**CASE NO.
2024-00310**

**RESPONSES TO MOUNTAIN ASSOCIATION AND KENTUCKIANS FOR THE
COMMONWEALTH'S SUPPLEMENTAL INFORMATION REQUEST
TO EAST KENTUCKY POWER COOPERATIVE, INC.**

DATED DECEMBER 2, 2024

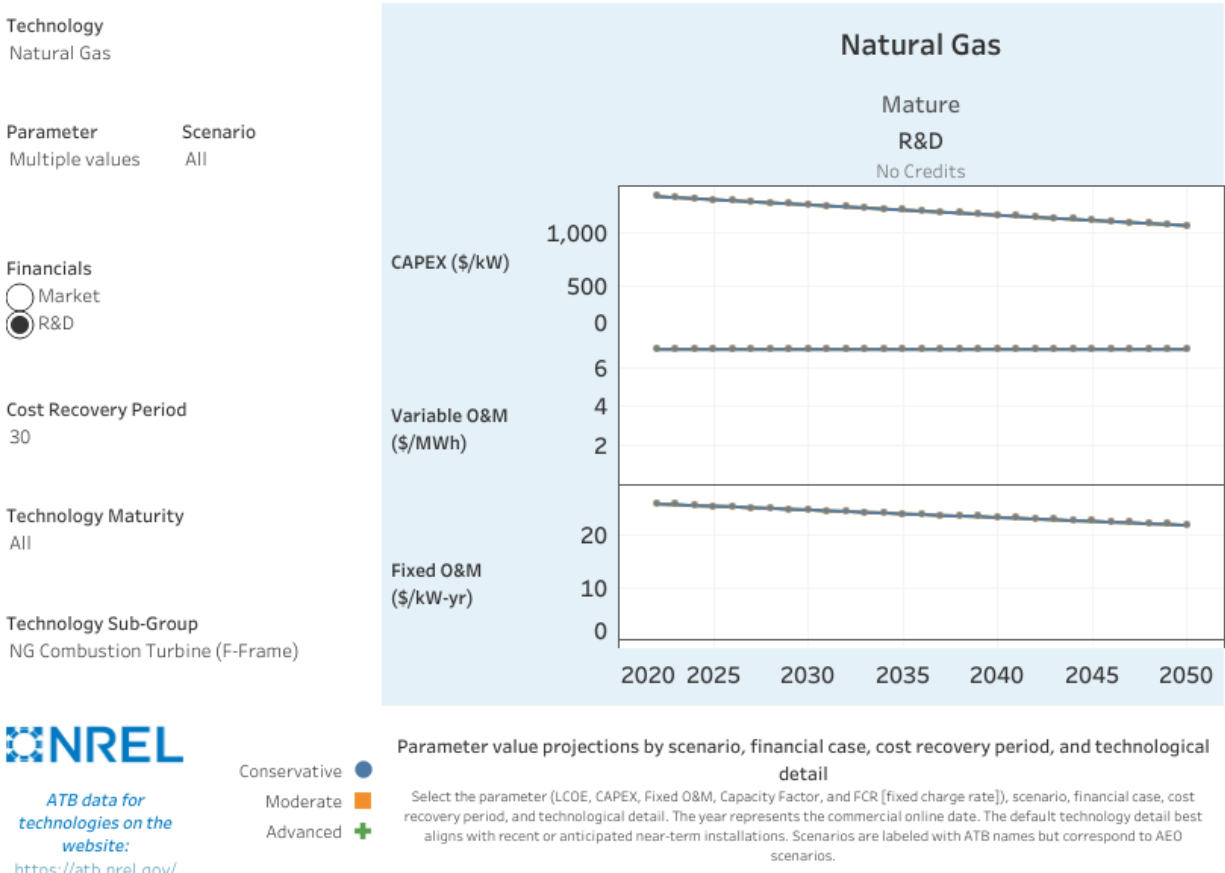
d. Please provide support for the assertion that "RICE engines have lower operating and maintenance ('O&M') costs than the traditional combustion turbine."

d. Refer to the direct testimony of Julia J. Tucker, page 23, lines 14-23. Operations and maintenance costs ("O&M") for the F-Class CT were sourced from the National Renewable

Energy Lab (“NREL”) Annual Energy Baseline (“ATB”)¹, see image below for reference:

Comparable O&M costs for the RICE units were sourced from Attached BY-1, the Project Scoping Report submitted in this Application, page 1-5, Table 1-2: Annual O&M Costs.
